U.S. Department
of Transportation
**Federal Highway
Administration**

In Reply Refer To: HSSD/B-69C

Thank you for your October 25, 2007, e-mail requesting Federal Highway Administration (FHWA) acceptance of a minor modification to your company's Variable Length Barrier (VLB) elements of the Reactive Tension Quickchange Moveable Barrier System as a Test Level 3 device for use on the National Highway System (NHS). You requested that we find this device acceptable for use on the NHS under the provisions of National Cooperative Highway Research Program (NCHRP) Report 350 "Recommended Procedures for the Safety Performance Evaluation of Highway Features."

16" RTS VLB-WITH SPRINGS
1/4" SHELL

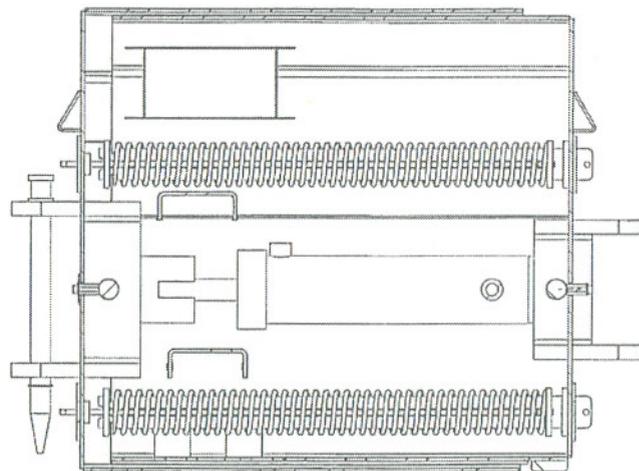
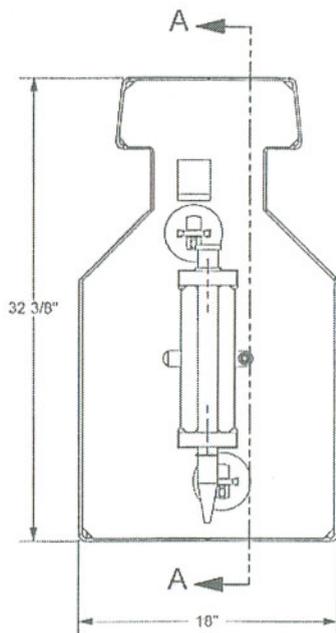
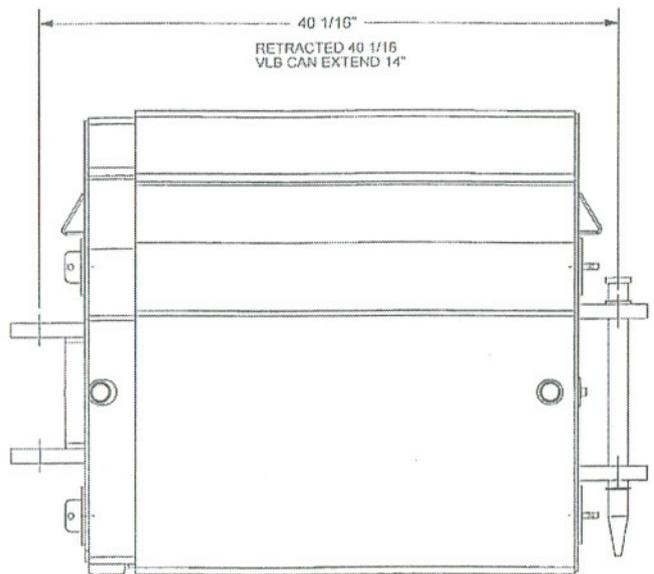
Our letter B-69 dated June 27, 2000, found the Steel Reactive Tension System (SRTS)/Concrete Reactive Tension System (CRTS) acceptable for use. You propose to remove the spring from the VLB segments as they have been found to be unnecessary for the proper operation of the Reactive Tension Barrier. We concur with your conclusion that the removal of the springs in the VLB units will not affect the impact performance of the system and the Reactive Tension Quickchange Moveable Barrier would be expected to perform in a similar manner to that indicated in the FHWA acceptance letter for this product.

Therefore, the system described above and detailed in the enclosed drawing is acceptable for use on the NHS under the range of conditions the RTS was tested, when proposed by a State agency.
